PLANNING DEPARTMENT – Development Review Services

**RE: Sevilla @ Andalucia - (File: F11D015C)**  
**Drainage Management Plan, Engineer's Stamp Date 1-19-2015**  
**Grading and Drainage Plans, Engineer's Stamp Date 1-19-2015**

Re: Response to Comments  
Drainage Master Plan for Sevilla @ Andalucia

# DRAINAGE MASTER PLAN FOR SEVILLA @ ANDALUCIA

**STORM DRAIN PLAN AND PROFILE**

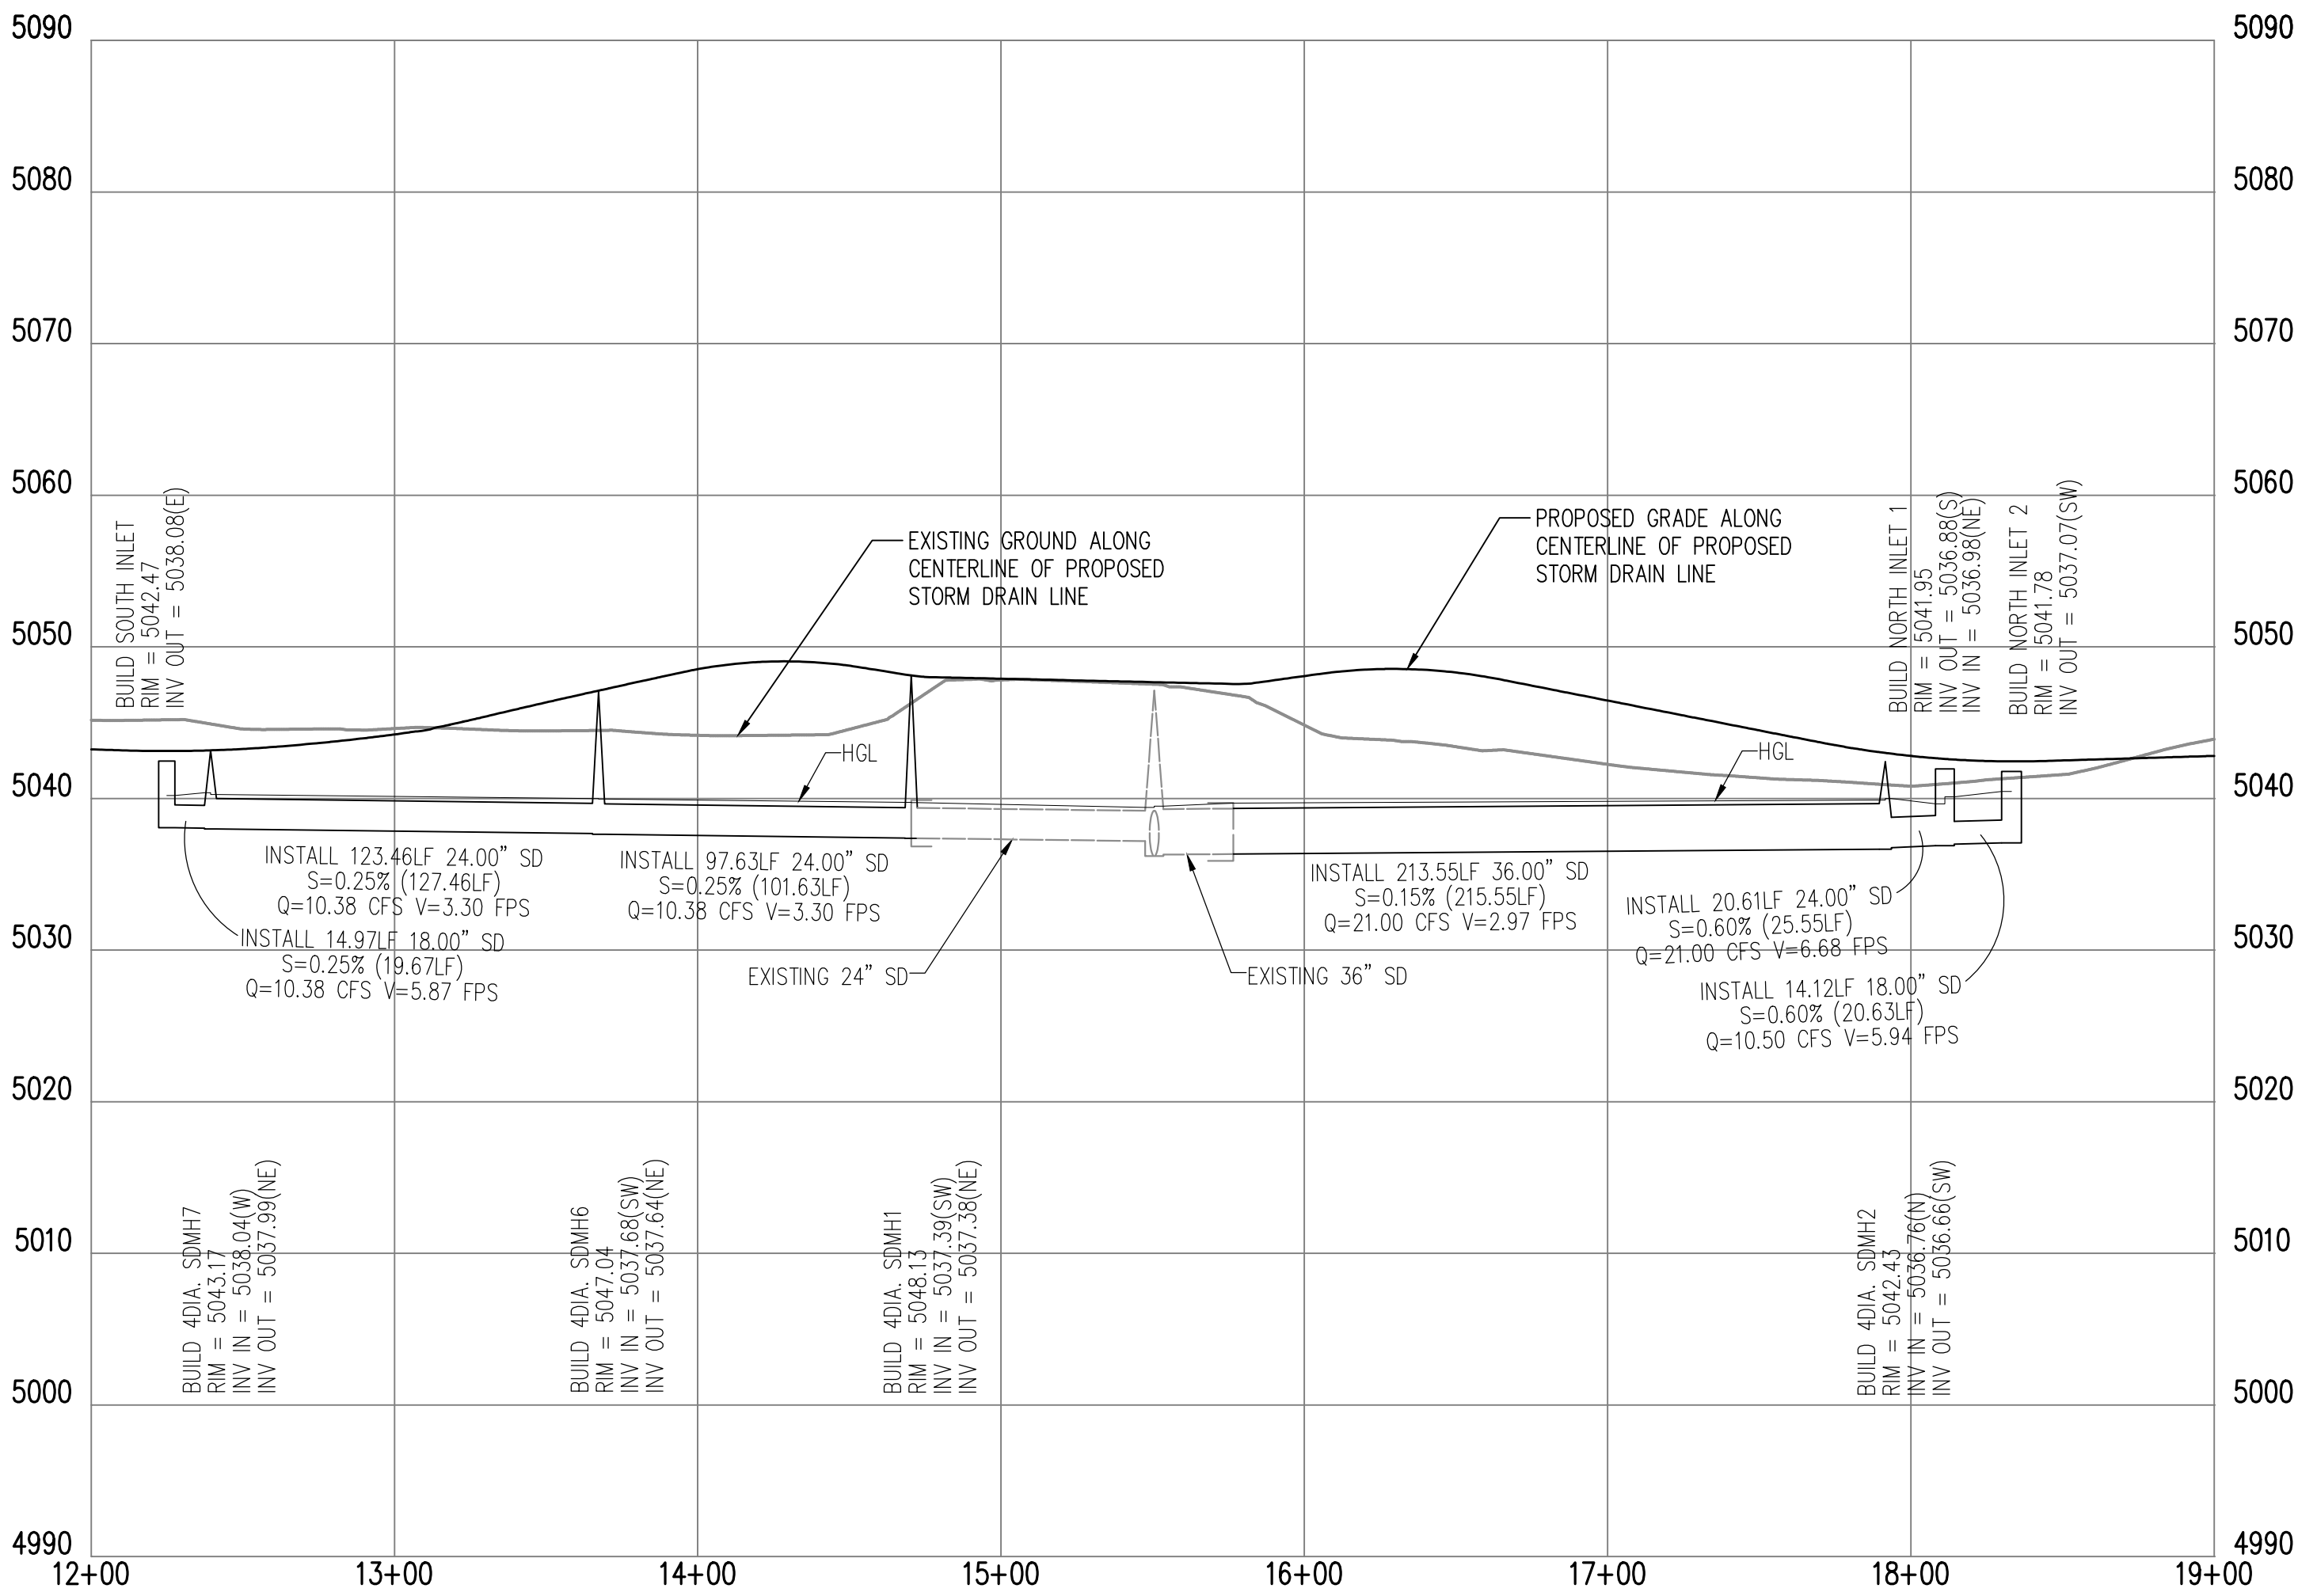
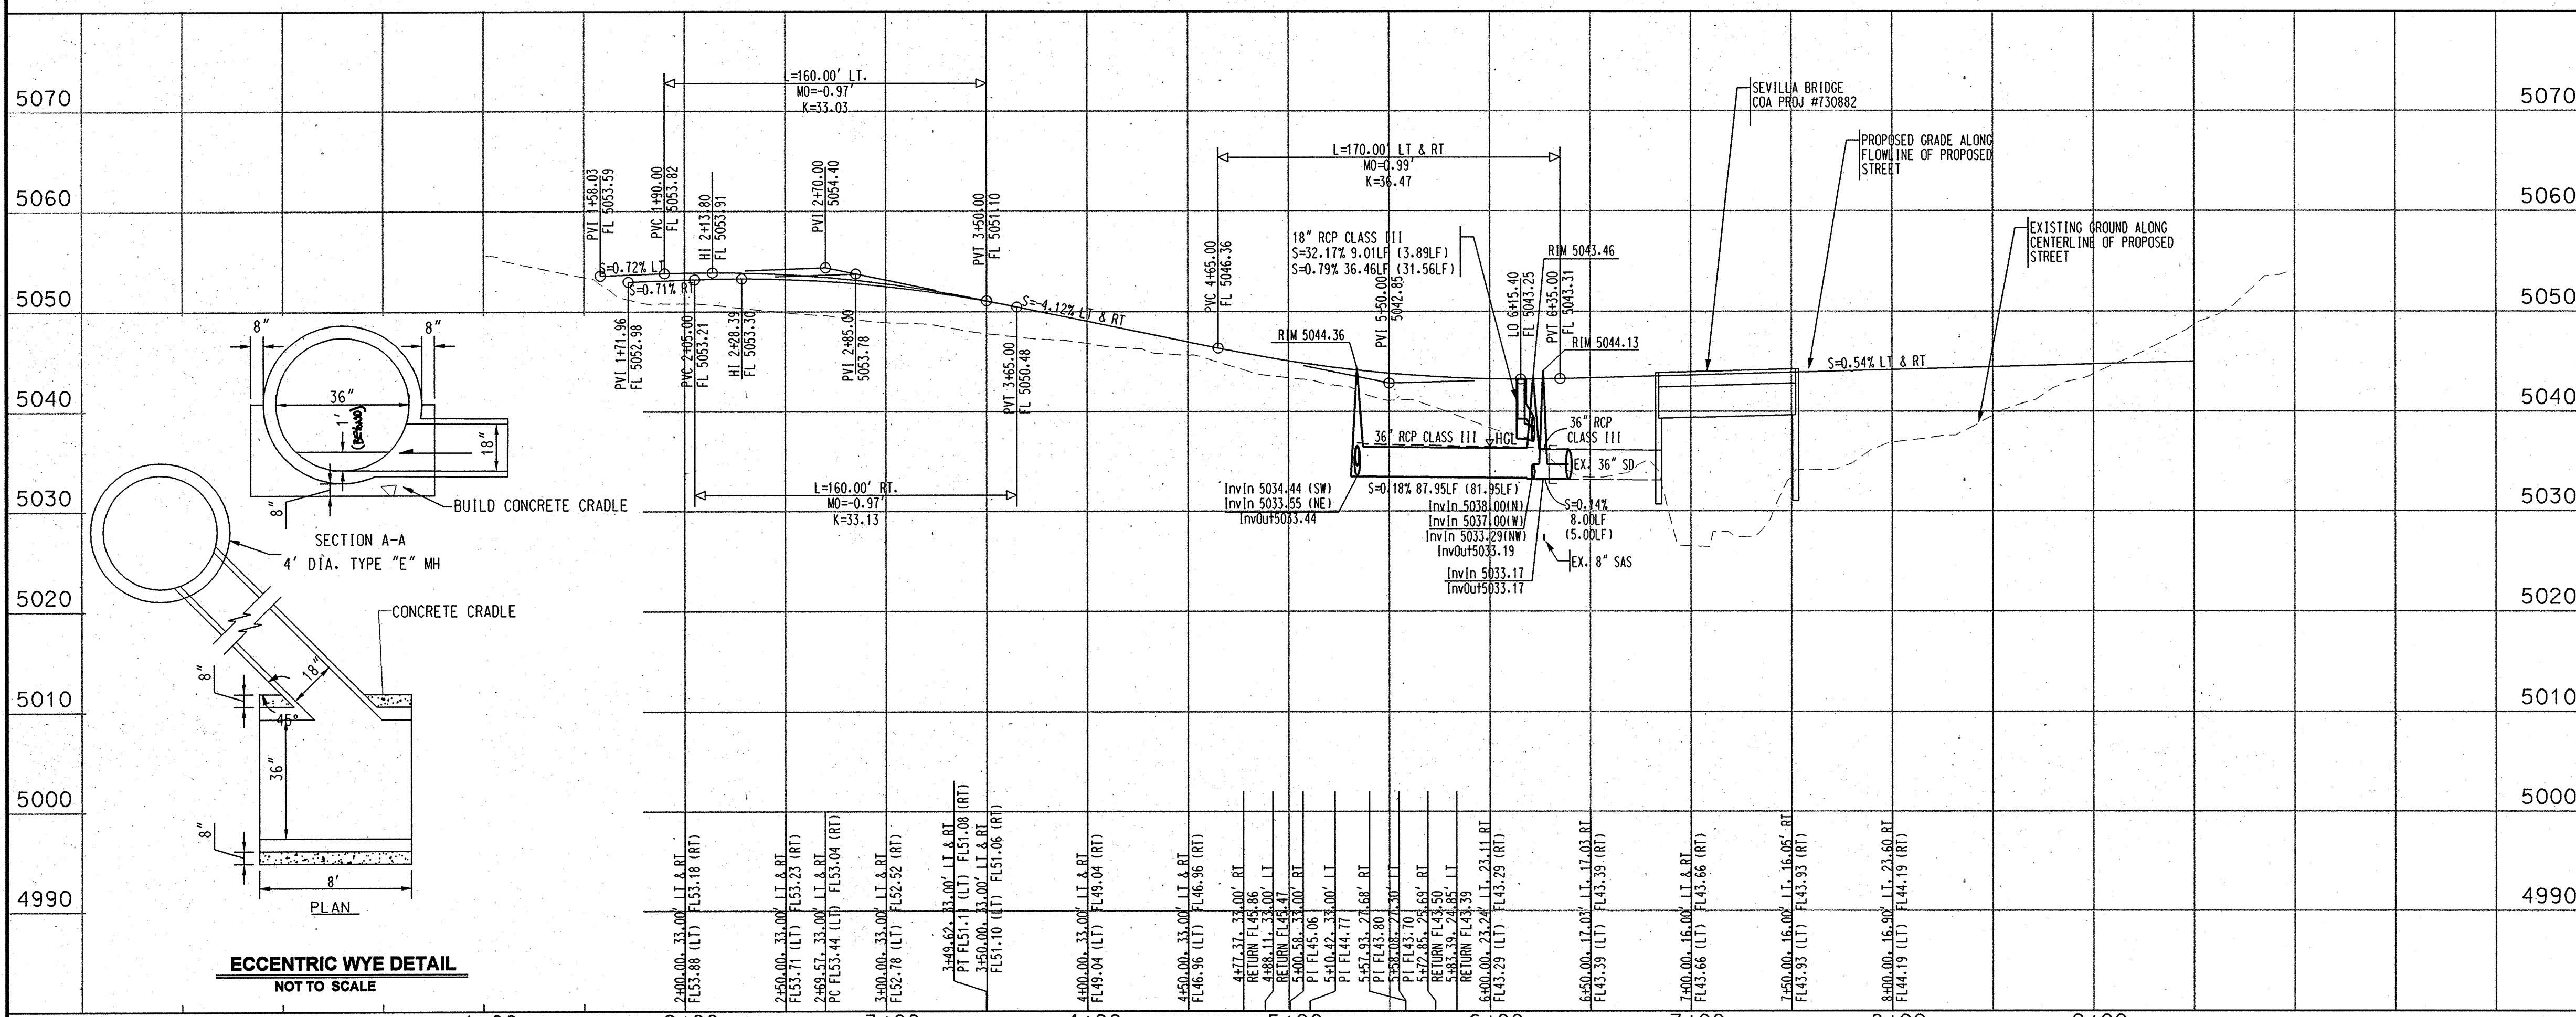
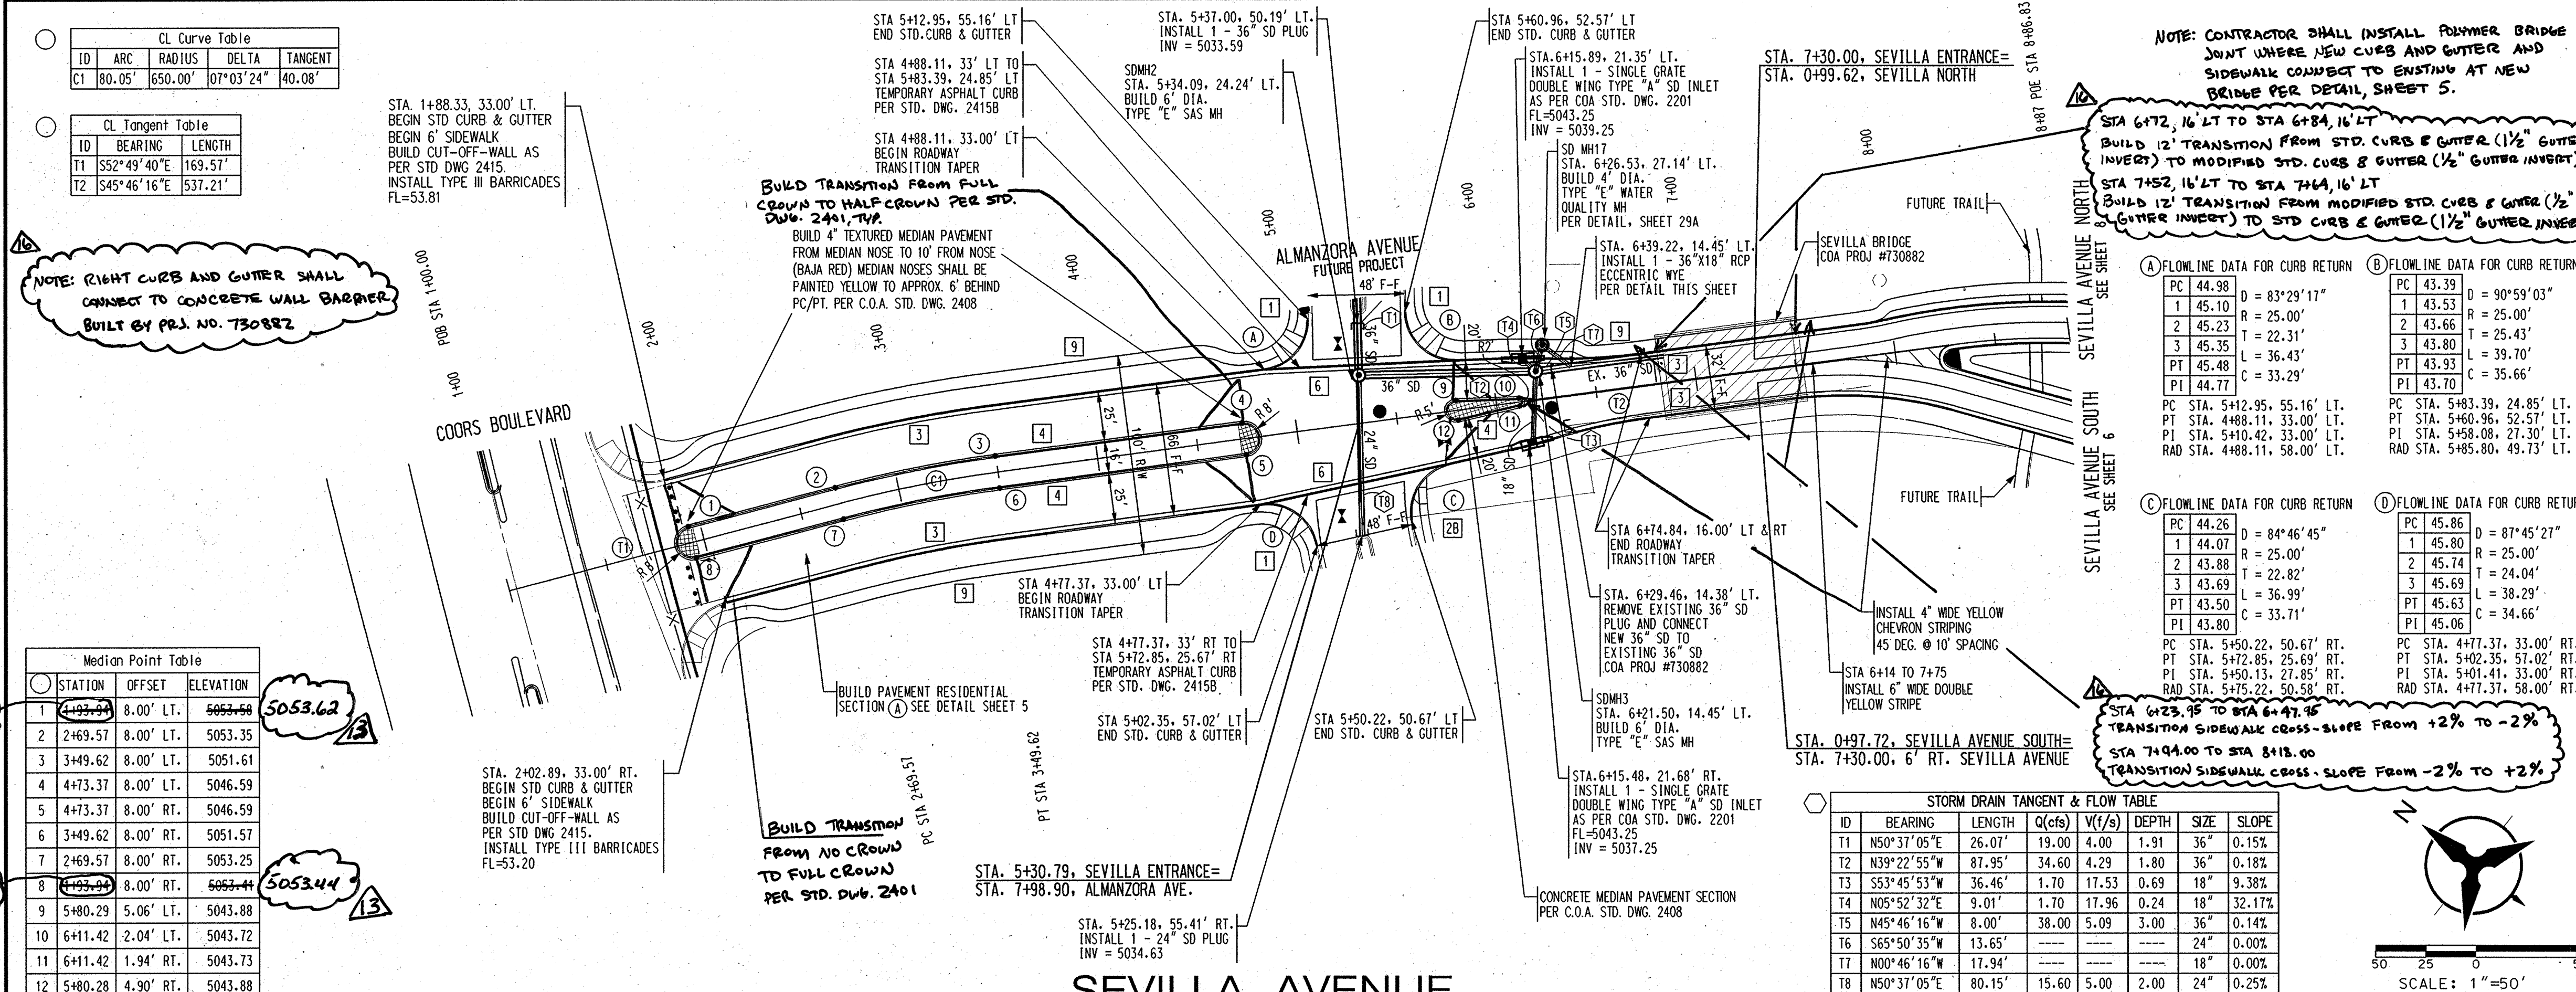
- **The analysis provided in Appendix B is for a super elevated roadway.**
26. For the storm drain analysis, provide a graphic representation showing the storm drain, the grade, the HGL and the pipe ID's used in the InRoads program.

4. Provide additional information for the  $Q_{allowable}$  vs.  $Q_{design}$  for the existing 36" storm drain network in Sevilla Ave.
  - **As shown in the *Andalucia at La Luz – Unit 1* as-built for the above mentioned storm drain, the flow from the previously approved plans discharging to the existing 36" storm drain network is  $Q=34.6$  cfs . As shown in this report, Sevilla @ Andalucia has a  $Q=31.6$  cfs entering the storm drain network, thus there is no adverse effect to the existing storm drain network with this development. The asbuilt plan and profile sheet has been added as Exhibit 5**

- **Plan and profile sheets have been included in the report with the above information.**
